***Re: Cleveland School of the Arts – Cleveland, Ohio
Stormwater Management and Connection Approval***

SEWER CONNECTION PERMIT

PERMIT NO:
20140010

C2.01

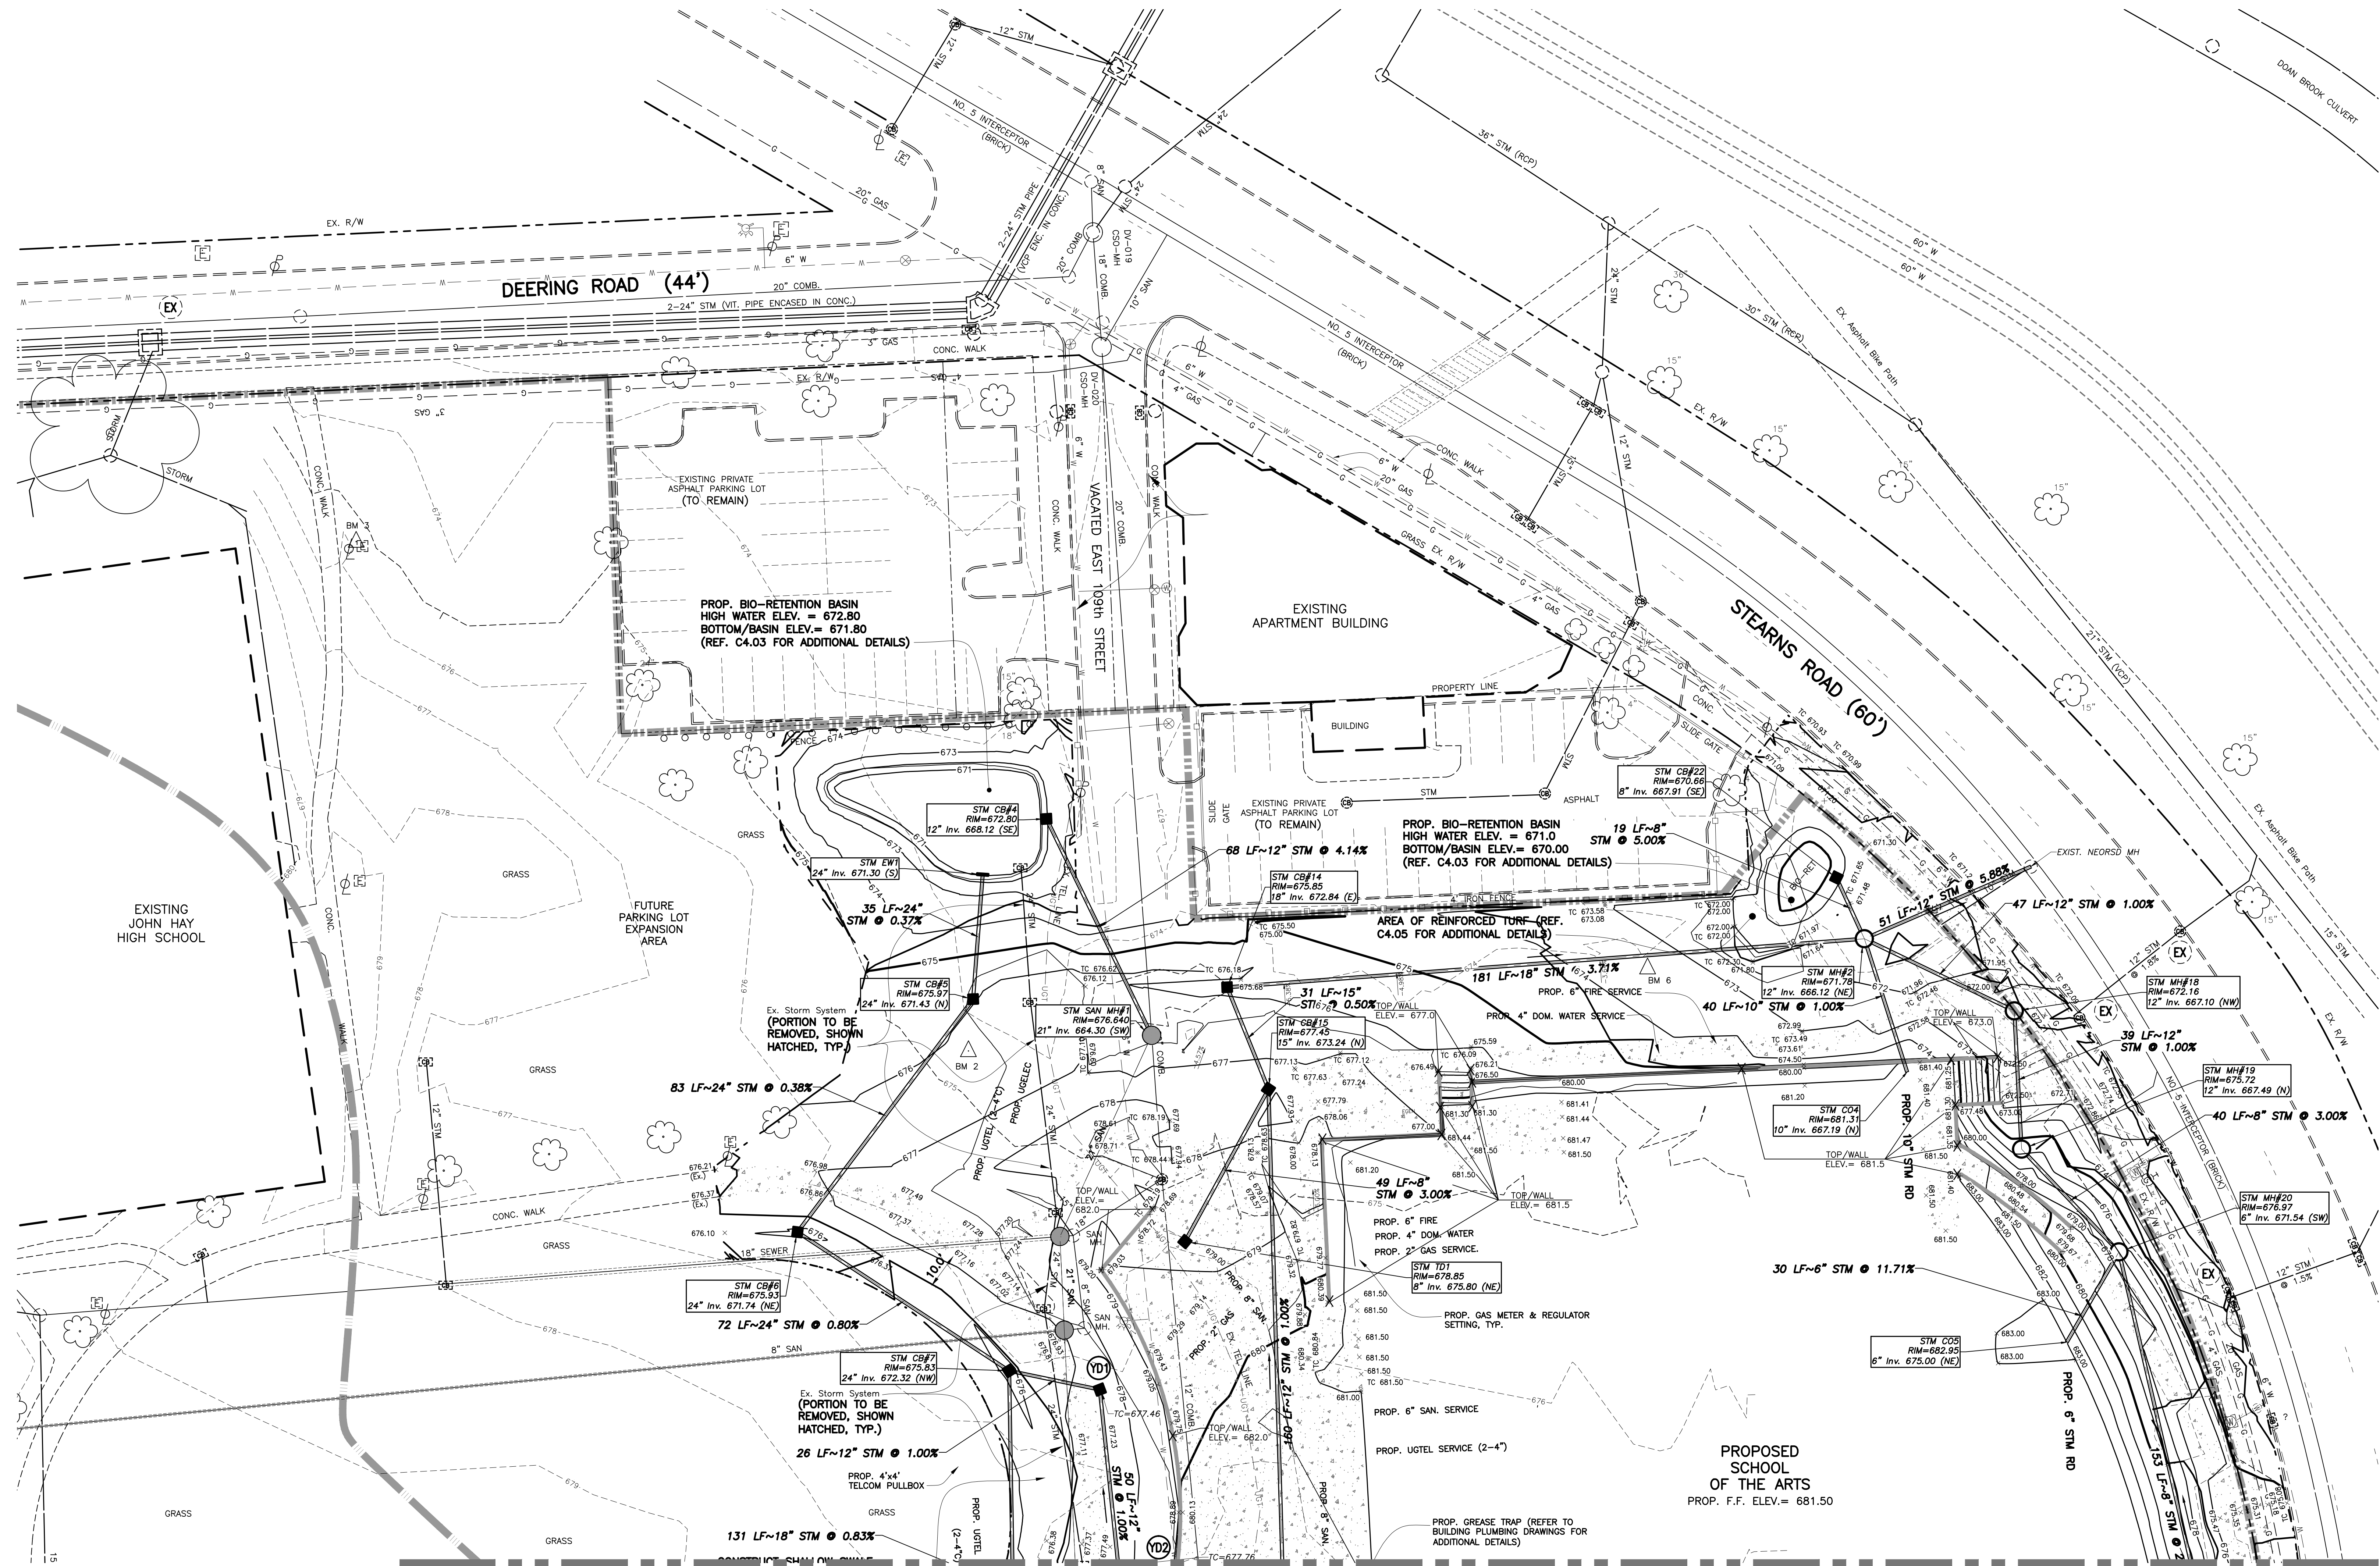
THE DISTRICT HEREBY AUTHORIZES THIS CONNECTION TO ITS FACILITY PROVIDED THE FOLLOWING CONDITIONS ARE MET.

* PROVIDE PRE-CONSTRUCTION AND POST-CONSTRUCTION VIDEO INSPECTION OF THE INTERCEPTOR SHOWING A FOOTAGE MEASUREMENT FROM THE EITHER THE UPSTREAM OR THE DOWNSTREAM MANHOLE AND EXTENDING A MINIMUM OF 20 FEET PAST THE CONNECTION POINT. THE FORMER SHALL BE SUBMITTED TO THE DISTRICT FOR APPROVAL PRIOR TO THE COMMENCEMENT OF WORK.

* THE CONNECTION SHALL BE MADE THROUGH A PROPERLY SIZED CORED HOLE. IF THE CONNECTION IS TO A REINFORCED CONCRETE OR VITRIFIED CLAY PIPE THEN THE LATERAL SHALL BE CONNECTED TO THE SEWER USING A MANUFACTURED BOOT THAT MAKES A WATERTIGHT CONNECTION. IF THE CONNECTION IS TO A BRICK SEWER THEN THE LATERAL SHALL BE CONNECTED BY WRAPPING A WATERSTOP MATERIAL SUCH AS A VOLCLAY RX101 OR EQUAL AROUND THE LATERAL. 2 WRAPS MINIMUM IN ACCORDANCE WITH THE ATTACHED DETAIL. IF WATERSTOP MATERIAL IS USED, THE ANNULAR SPACE BETWEEN THE SEWER WALL AND THE LATERAL SHALL BE FILLED WITH HYDRAULIC CEMENT. EITHER TYPE OF CONNECTION SHALL THEN BE ENCASED IN CONCRETE.

THE FOLLOWING CONDITIONS APPLY TO EITHER THE USE OF AN EXISTING LATERAL OR THE CONSTRUCTION OF A NEW LATERAL.

- * THE OWNER SHALL WARRANT THAT THE CONNECTION WILL BE WATERTIGHT FOR A PERIOD OF ONE YEAR.
- * THE CONTRACTOR IS RESPONSIBLE FOR ANY AND ALL DAMAGE TO THE INTERCEPTOR AS DETERMINED BY THE DISTRICT.
- * THE CONTRACTOR SHALL PREVENT ANY DEBRIS FROM ENTERING THE SEWER. ANY DEBRIS ENTERING THE SEWER SHALL BE REMOVED BY THE CONTRACTOR.
- * THE CONTRACTOR SHALL PROVIDE AN "AS-BUILT" DRAWING OF THE CONNECTION UPON A COMPLETION OF THE WORK.
- * THE CONTRACTOR IS RESPONSIBLE FOR OBTAINING ANY AND ALL PERMITS REQUIRED FOR THE WORK.
- * A 72-HOUR NOTICE SHALL BE PROVIDED TO MR. ERIC PARHAM OR MR. THOMAS MADEJ (216-641-6000) TO SCHEDULE A DISTRICT INSPECTOR FOR THE CONNECTION.
- * ALL SUBMITTALS SHALL BE SENT TO THE DISTRICT ATTN: MR. BRIAN PAGE AT THE LETTERHEAD ADDRESS.

WYE OR LATERAL DETAILS:

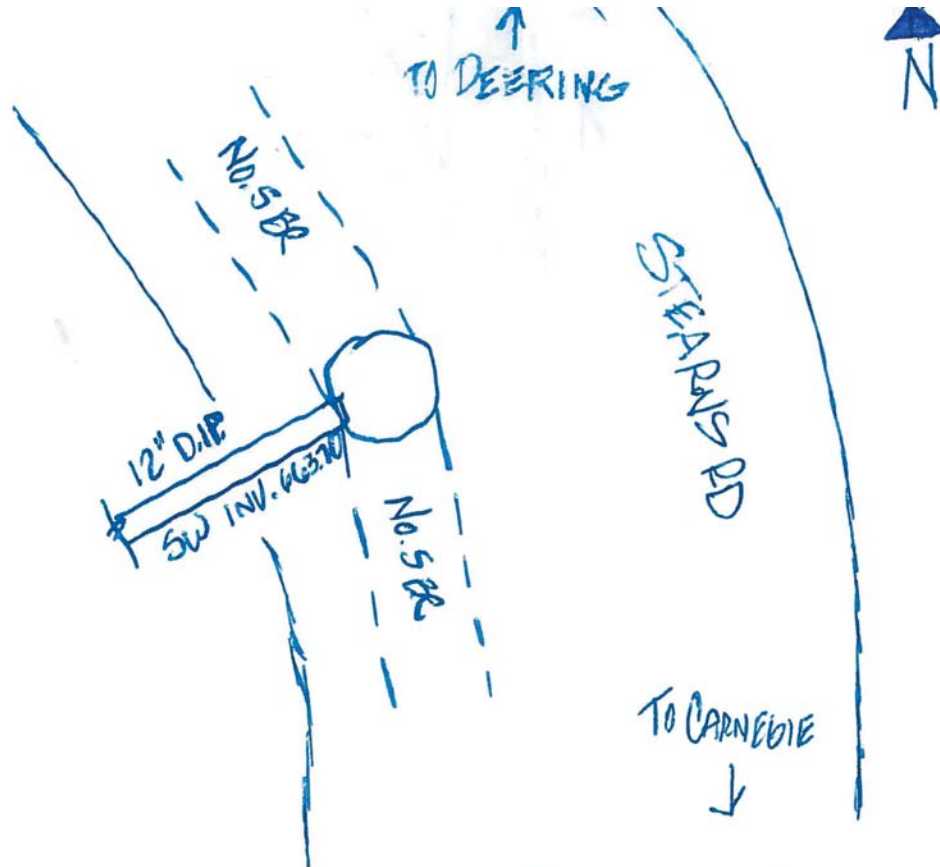
Contractor filled annular space between new D.I.P. pipe and brick MH with hydraulic cement from outside of barrel. Contractor then formed concrete collar around new D.I.P. pipe on outside of barrel.
